ADDENDUM No. 1

Subject: Gen. Philip Kearny School
Roof Replacement
SDP Contract No.:B-058 C of 2016/17

Location: 601-19 Fairmount Avenue
Philadelphia, PA 19123

SK-1

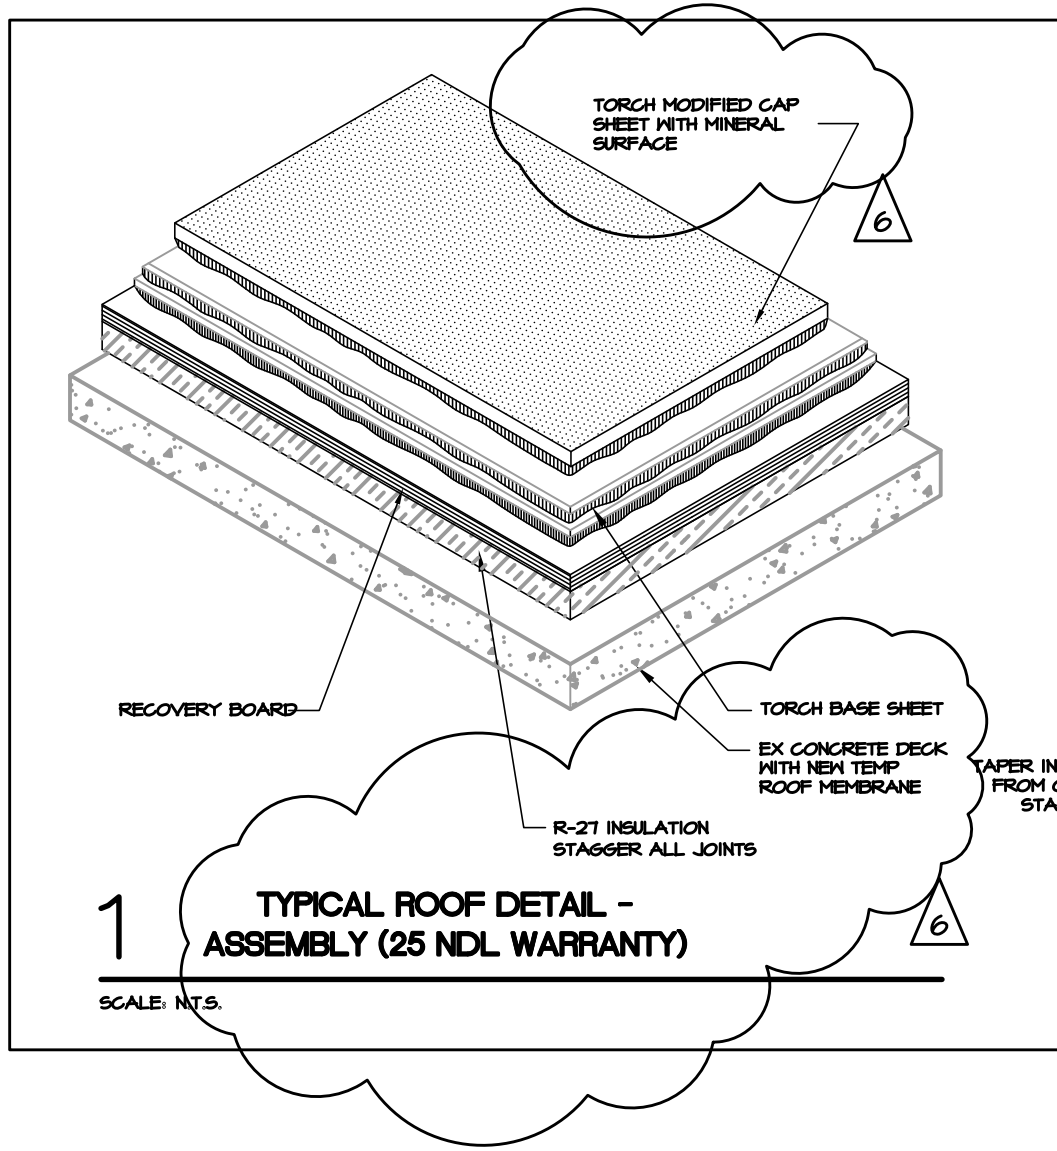
2. The summary of work section 01 1000 – 1.1.2 – Call for R-27 insulation, but the proposed condition chart and detail 1/R-400 show R-20.0 insulation. Which is correct?
 - a. R-27 insulation is required by code.
 - b. Detail 1/R-400 has been corrected and included as SK-1.

2 TYPICAL ROOF DETAIL - ROOF DRAIN

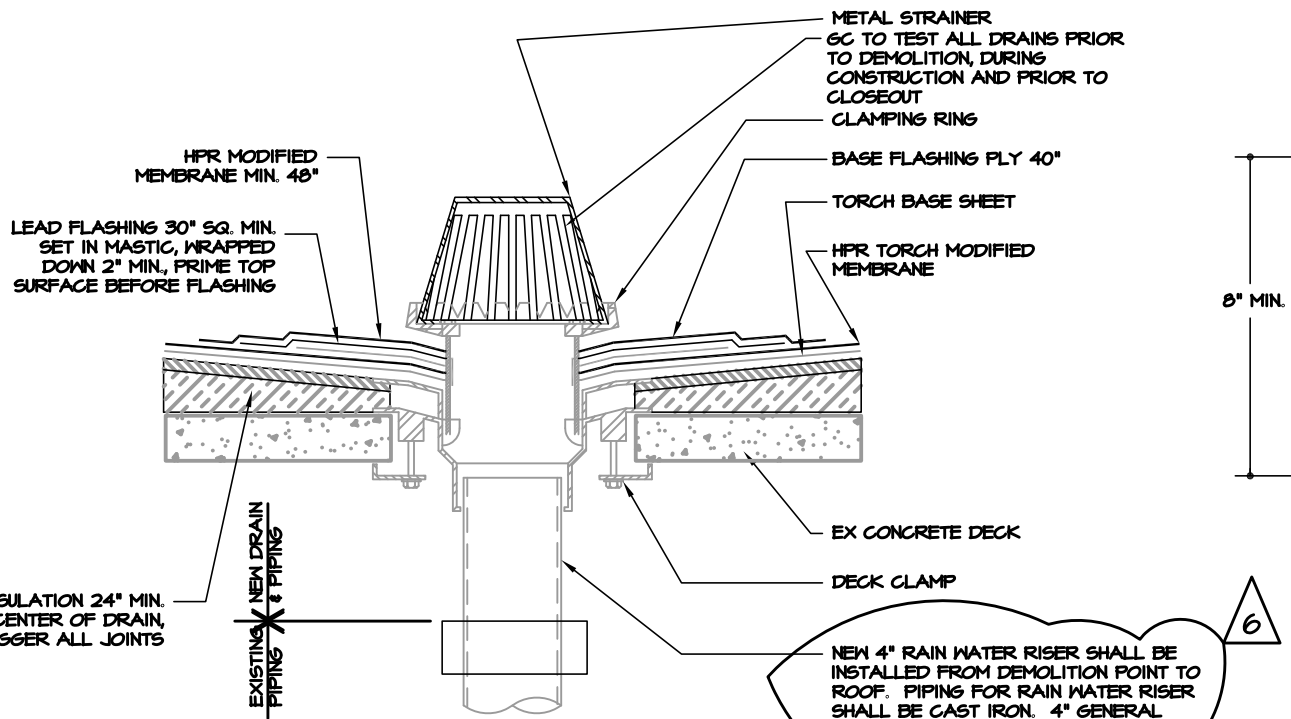
3. The summary of work section 01 1000 – 1.1.3 - Call to replace the strainers. Do just the strainers get replaced or the entire drain? The way Detail 2/R-400 is shaded it looks like only the strainer is getting replaced. If the drains do get replaced can you please provide a drain spec?
 - a. Detail 2/R-400 shows the existing piping and the new piping.
 - b. Drain information has been added to 2/R-400 and included as SK-2.

SK-3

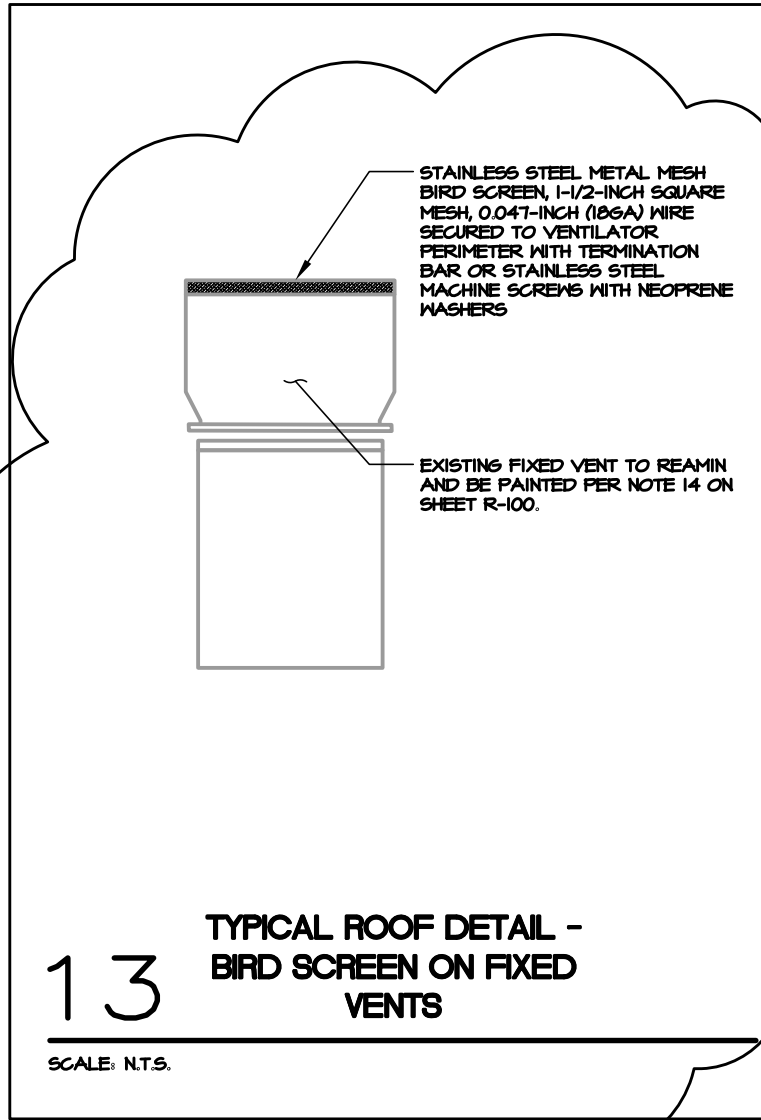
4. The summary of work section 01 1000 – 1.1.6 - State to install bird screen at all mechanical vents. Can you please clarify which vents you want bird netting and can you provide a spec and detail for the bird netting?
 - a. Refer to note 14 on R-100, which is also indicated on plan.
 - b. See SK-3 for detail for the bird screen netting.
